UNITED STATES PATENT AND TRADEMARK OFFICE

APPLICATION NO.	FILING DATE	FIRST NAMED INVENTOR	ATTORNEY DOCKET NO.	CONFIRMATION NO.
10/081,928	02/20/2002	Isreal Hicks	HICKS-1-1002	2184

Office Action Summary

DETAILED ACTION

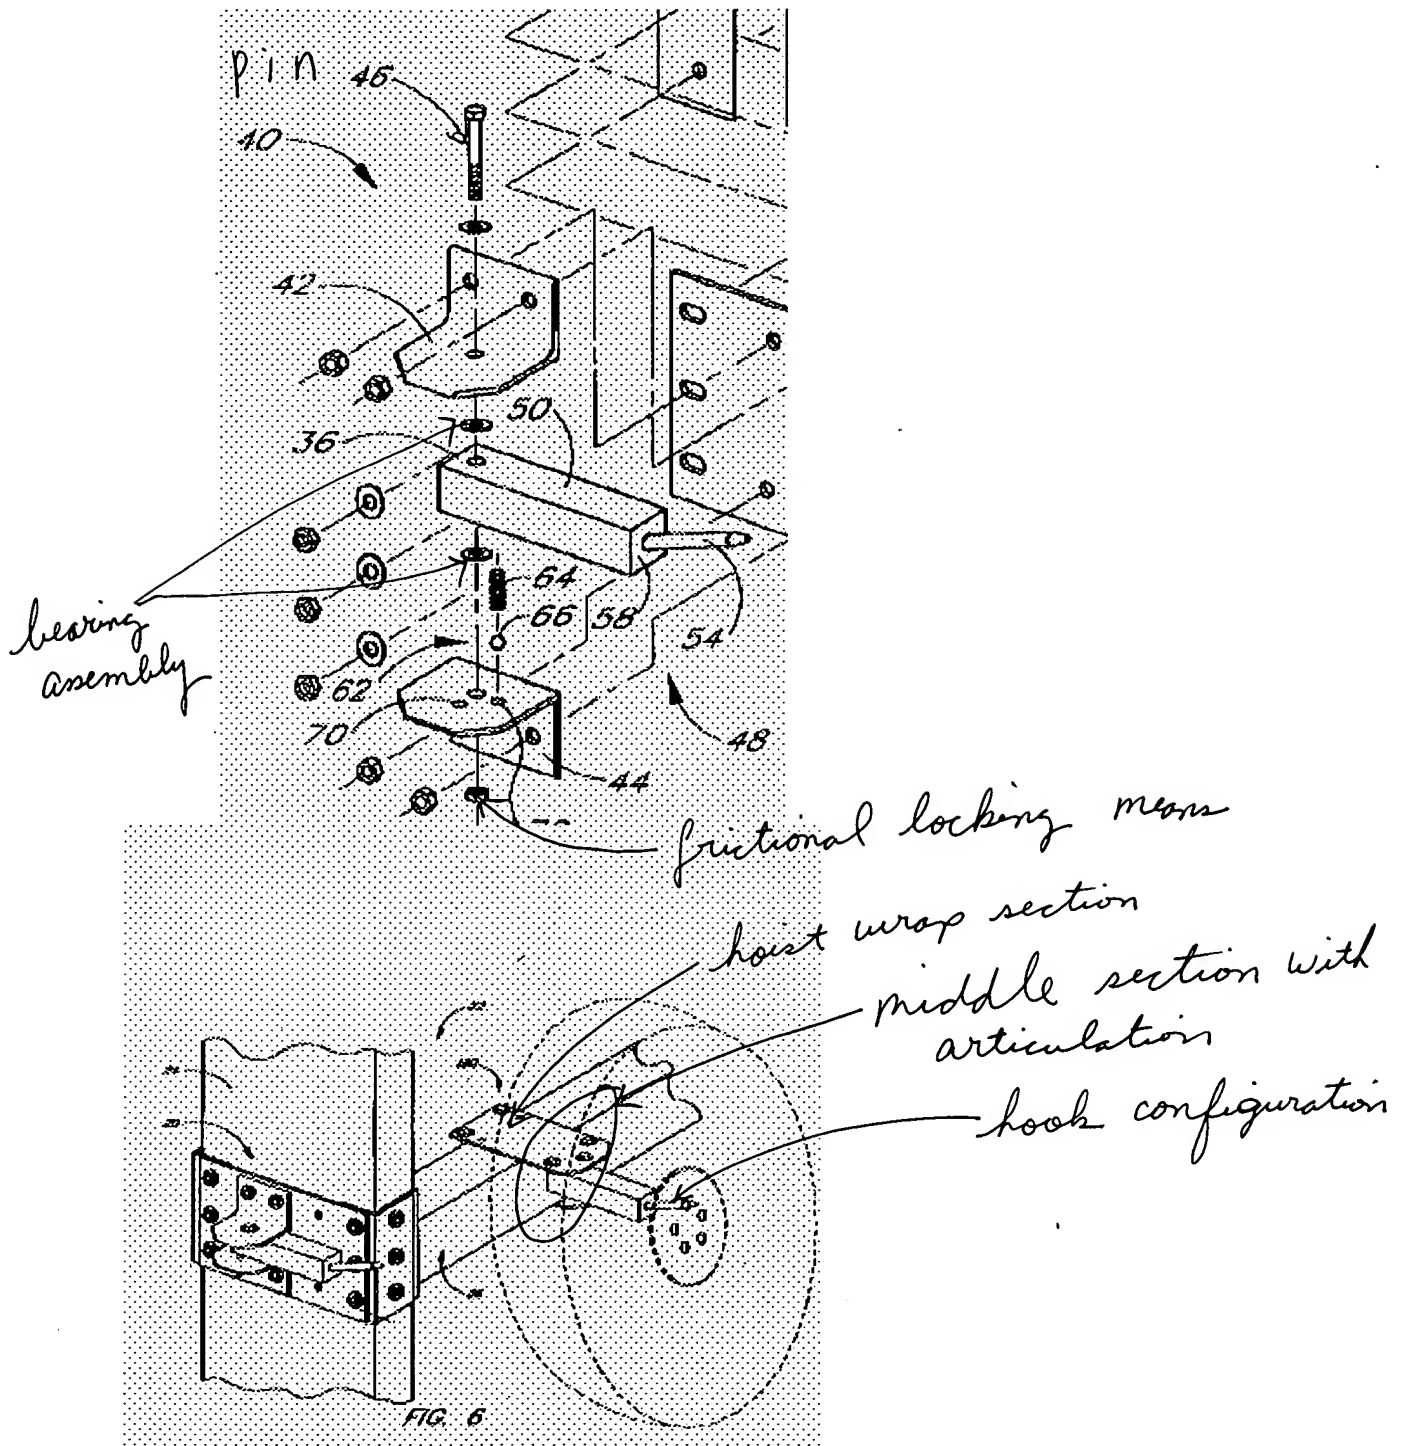
Claims 21-25, 30-32, 38, 39, and 41-47 are rejected under 35 U.S.C. 102(b) as being anticipated by Starling et al (WO 00/55031). Starling discloses a tire hanger (120, see illustration below) comprising a hoist wrap section having an open end arranged to removeably engage to the horizontal support member of a vehicle hoist; a tire hanging section arranged to engage axle of a wheel; and a middle section disposed between the hoist wrap section and the tire hanging section wherein the middle section having a length and having an articulated joint, whereby the hoist wrap section is shaped so as to wrap around the horizontal support member of the vehicle hoist. Further, Starling's hoist wrap is inherently can be slidably positionable along the horizontal support member at a user-selected a location when the nuts are loosened. Starling also further discloses the pivot joint includes a bearing assembly (see illustration below), a pin (46, figure 2), and a frictional locking device (nut).
